ADDENDUM NO. 1

Date of Addendum: May 27, 2016

Project: Mercey Springs Sewer Line Replacement

Owner: City of Los Banos

ATTACHMENT 1

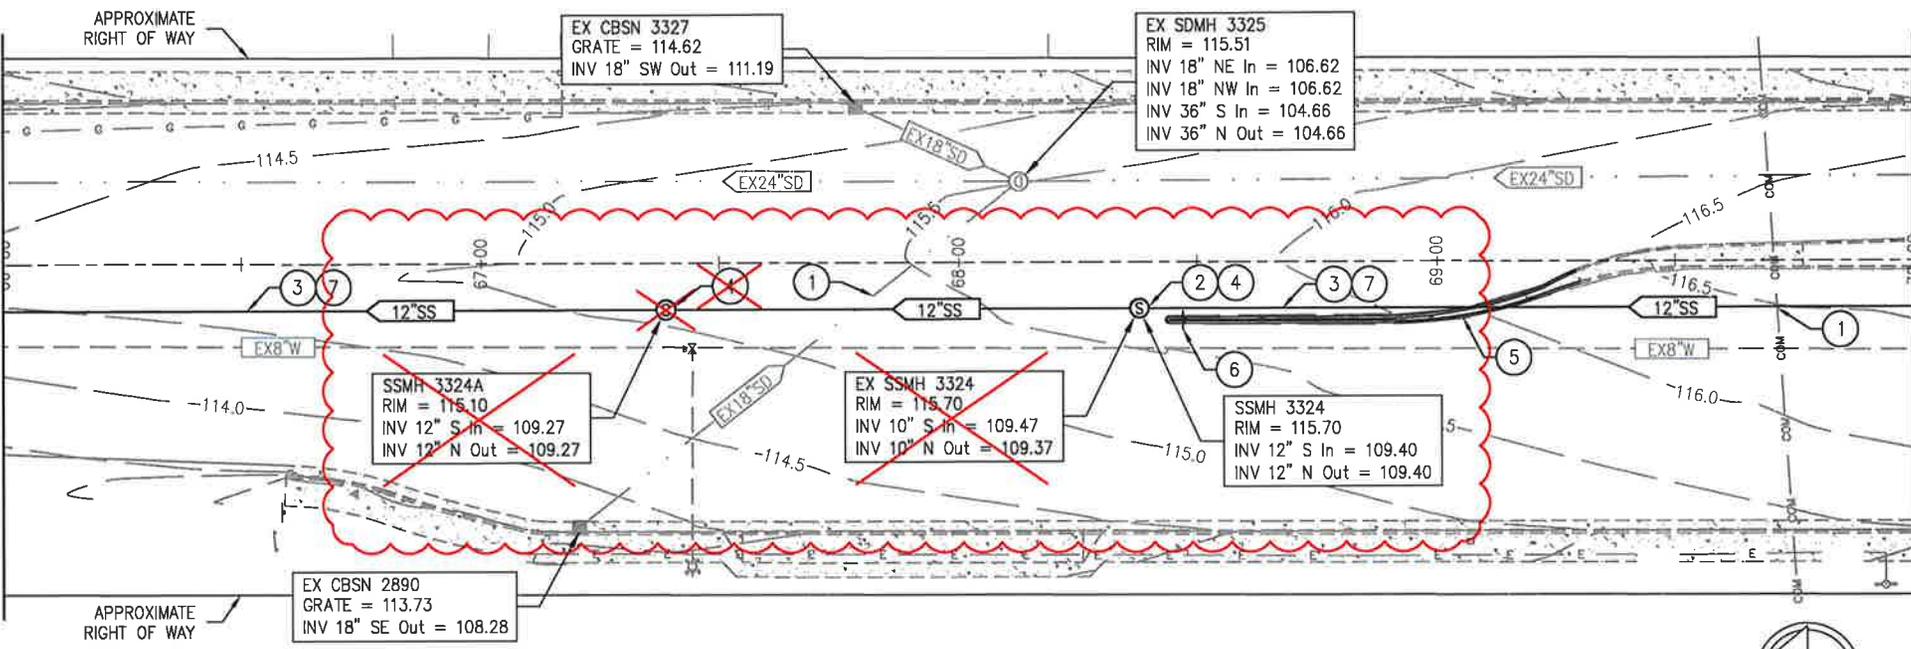
3. The Plans are hereby modified to effect the following changes:
 - a) Sheet 18, Drawing C-118
 1. Proposed manhole SSMH 3324A shall be constructed at station 68+37.86 and referenced as SSMH 3324 (Attachment 1).

~~SSMH 3324A
RIM = 115.10
INV 12" S In = 109.27
INV 12" N Out = 109.27~~

~~EX SSMH 3324
RIM = 115.70
INV 10" S In = 109.47
INV 10" N Out = 109.37~~

SSMH 3324
RIM = 115.70
INV 12" S In = 109.40
INV 12" N Out = 109.40
